PROJECT: **LOT 103 SPENCERS BROOK-YORK YORK**

DA ASSESSMENT REPORT

DA No. P963

Proposal: Dirt go-kart racing track

SITE PLAN

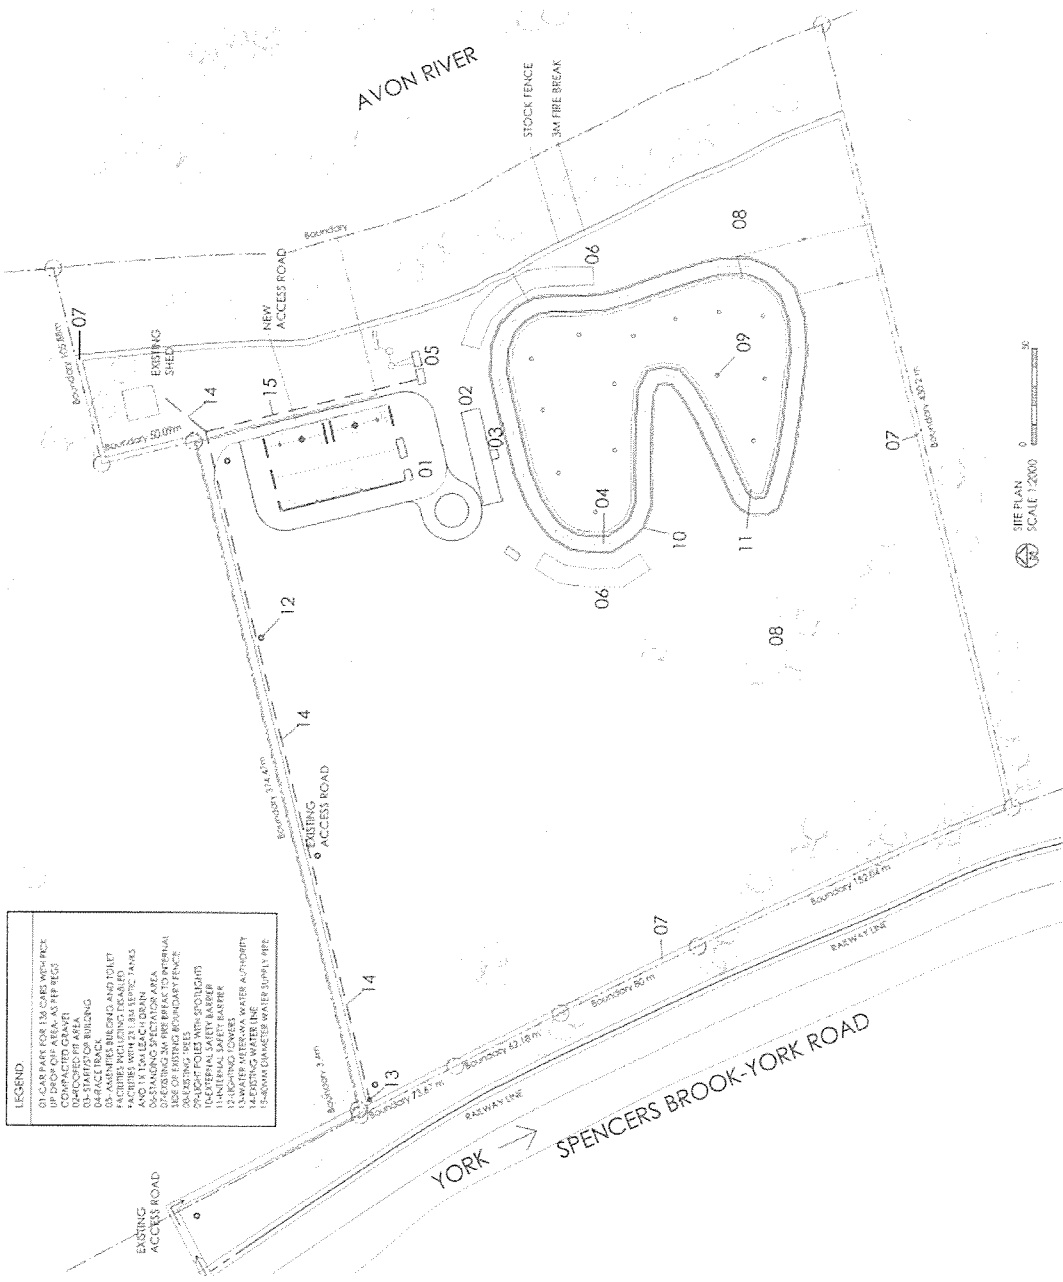
m) Whether the land to which the application relates is unsuitable for the proposal by reason of it being, or being likely to be, subject to flooding, tidal inundation, subsidence, landslip, bushfire or any other risk.
The original plans fell within the flood risk area. Amended site plans show all structures located outside the 100 year flood level.

The applicant is proposing the inclusion of 136 vehicle parking bays which have been marked on the plans, although scale does not enable their assessment against manoeuvring standards. Sufficient land is available on the land to meet the car parking requirements, therefore detailed parking plans can be assessed and approved as a condition of subdivision.
